# BLUE RIDGE ROAD

# BIKE & PEDESTRIAN IMPROVEMENTS PHASE 1 – TYPICAL SECTION COMMENTS

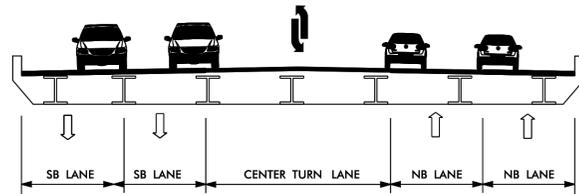
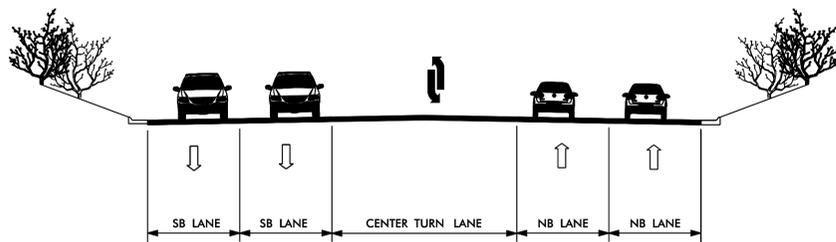
1. Multiple suggestions for a road diet, including reduced lane widths, and reducing the speed limit (to 25-35 mph) along this section and the entire corridor.

2. Can the lane width on the corridor be reduced to 11 feet? Sidewalks are ideally 14 feet wide.
3. Suggest a "Pop-Up Road Diet" close one lane of Blue Ridge for one day during the "Got to Be NC" festival as a demonstration project.

4. Destinations on both sides need sidewalks & transit/bus only lanes in both directions on Blue Ridge.
5. Would like to see a dedicated bus line on the Blue Ridge Corridor, especially since the Wake County Transit Strategy proposes two bus lines.

6. Street Lighting should be improved along the corridor.
7. Does NCSU have involvement in this project?
8. Need bike/ped facilities on both sides of the road.

9. Suggest adding transit stops along the corridor solar powered structures with wayfinding and branding. (Denver Style)
10. Multiple suggestions to add many street and shade trees "Tree Lined Promenade" along corridor

11. Suggest a separate off-road bike facility with a multi purpose bike and ped trail. Prefer asphalt.
12. Want a multi-use path on the west side of Blue Ridge from Reedy Creek to Trinity, with sidewalk on the east side.

13. Aim for a unified design throughout corridor.
14. Incorporate transit into the design, including transit stops.
15. Develop this corridor/street as a destination area.

16. Sustainability is an important consideration.
17. Use a 14 foot minimum multi-use path.
18. Use complete streets concepts including: tree-lined boulevard, traffic calming, solar powered transit stops, landscaped plazas, and pedestrian refuges.

19. Wayfinding should not be limited to the Greenway, but should be used throughout the corridor.
20. Consider a shuttle service from NCMA to Fairgrounds to help parking concerns.

21. Currently over 6 million people visit the Fairgrounds annually. The NCMA attracts 1 million and Rex has similar numbers.
22. In favor of sidewalks on both sides of Blue Ridge that are physically separate from bike paths and both are separated from vehicle lanes.

23. In general, need safer ways for pedestrians to cross Blue Ridge, especially at the Fairgrounds and NCMA. Suggested design elements include: Medians, blinking warning light for pedestrians, Speed bumps, Lower speed limit, An aerial gondola system.

24. Not in favor of tunnel crossings due to increased crime hazard.
25. Consider placing bike racks near bus stops on Blue Ridge for bike/bus commuters.

26. Install facility to direct bikes/peds to natural crossings.
27. Suggest a multi-use path or sidewalk with a 2-3 foot grass strip or crushed gravel like the American Tobacco Trail, then a bike lane.

28. Use updated (latest) Wayfinding over and above the Greenway standard.
29. Focus on the major crossings in this area: Westchase and District Drive.
30. In favor of bike lanes and sidewalks separated from road, on top of curb, with trees between curb and paths.

31. Bicycling should be the priority focus of the project. Include appropriate rest areas, water facilities, and greenspace.
32. Want a multi-use path on the west side of Blue Ridge from Reedy Creek to Trinity, with sidewalk on the east side.

33. Design to encourage pedestrian traffic to one side of Blue ridge.
34. Continuity with existing City Standards is important.
35. Need Pedestrian refuges at crossings and ramps.

36. See design examples in the Netherlands.
